802.3ak Amplitude Measurement

- Comment Summary
 - Current Definition is too loose
 - Define the measurement pattern
 - Define using mean

Current Definition

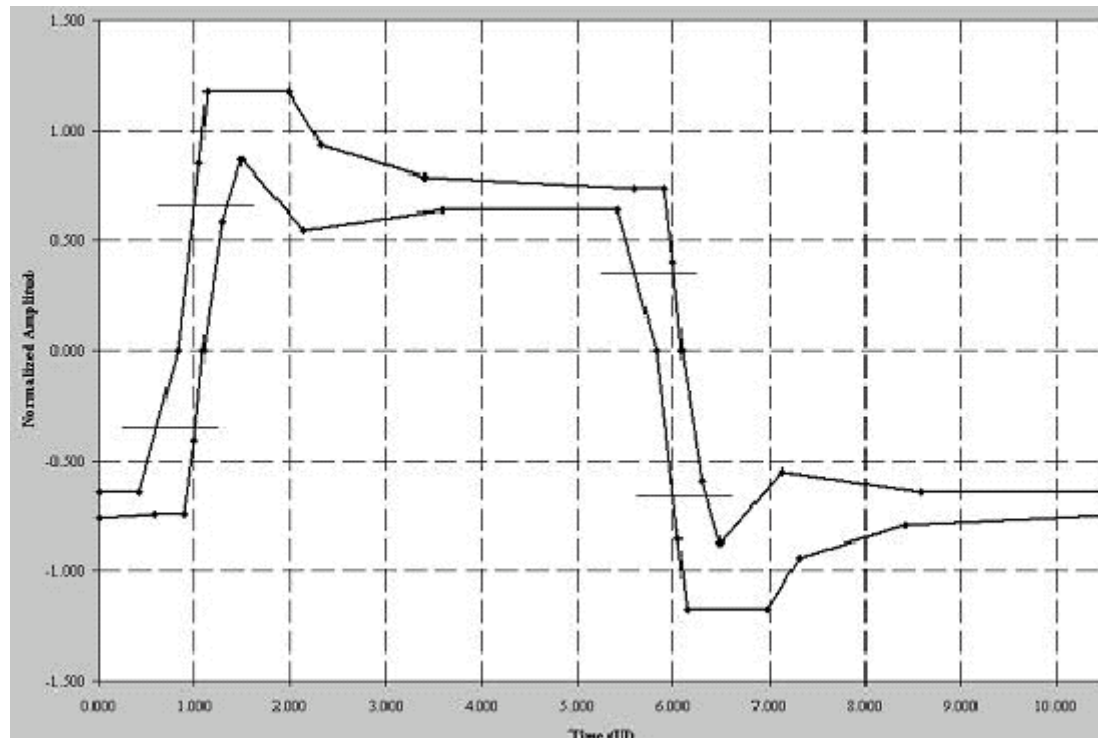
Transmitter maximum differential peak-to-peak output voltage shall be less than 1200 mVp-p. The minimum differential peak-to-peak output voltage shall be greater than 800 mVp-p. The maximum difference between any two lanes' differential peak-to-peak output voltage shall be less than or equal to 150mVpp. See Figure 54-4 [below; *prz*] for an illustration of definition of differential peak-to-peak output voltage.

Problem/Remedy:

- The pattern is *not* defined.
➔ Use the same pattern as for the Template test
